Work Order ID 82574

Item Name: Crosstube Turning Detail

DART AEROSPACE LTD	Work Order: 82574
Description: Crosstube Assembly (205/212/412 High Fwd)	Part Number: D212-664-141
Inspection Dwg: D212-664-141 Rev: D	Page 1 of 1

DRAWING NO. D212-664-141	TITLE XTUBE ASSY (205/212/412 HI FWD)	REV. D	DART AEROSPACE LTD ENGINEERING ORDER		D.E.O. NO. D212-664-141-D-1	SHEET NO. SHEET 1 OF 2	SCALE NTS
DRAWN	CHECKED <i>JP</i>	MFG. APPR. <i>R</i>	APPROVED <i>MP</i>	DE APPR. <i>MP</i>			
DATE 11.04.07	DATE 11.07.11	DATE 11.04.12	DATE 11/04/12	DATE 11.04.12

**D212-664-141/-141B
ASSEMBLY DETAIL**

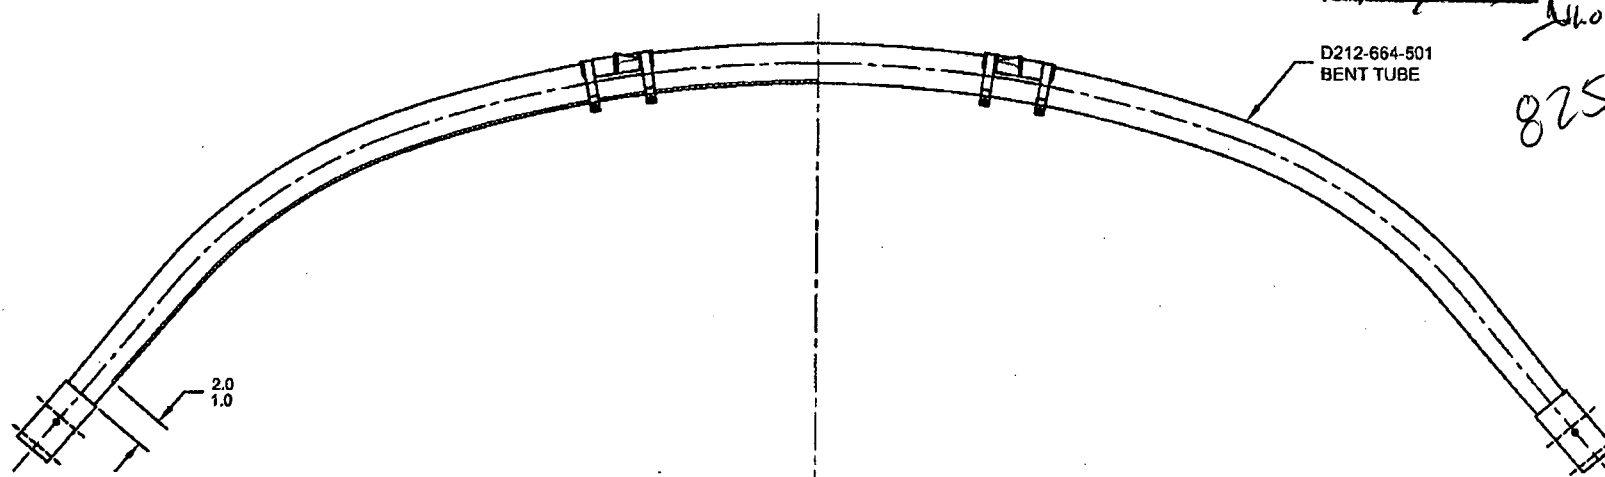
PURPOSE:

ADD AN INSPECTION WINDOW TO UNDERSIDE OF CROSSTUBE.

NOTES 2 OF SHEET 1 IS AMENDED AS FOLLOWS:

IS:

- 2) FINISH: CHEMICAL CONVERSION COAT PER DART QSI 005 4.1
PRIME INSIDE AND OUTSIDE PER DART QSI 005 4.2
MASK UNDERSIDE OF CROSSTUBE AS SHOWN (HATCHED AREA) AND
PAINT OUTSIDE PER DART QSI 005 4.2
REMOVE MASKING AND APPLY CLEAR COAT

MASK AREA PRIOR TO PAINTING,
REMOVE MASKING AFTER PAINT
AND APPLY CLEAR COAT
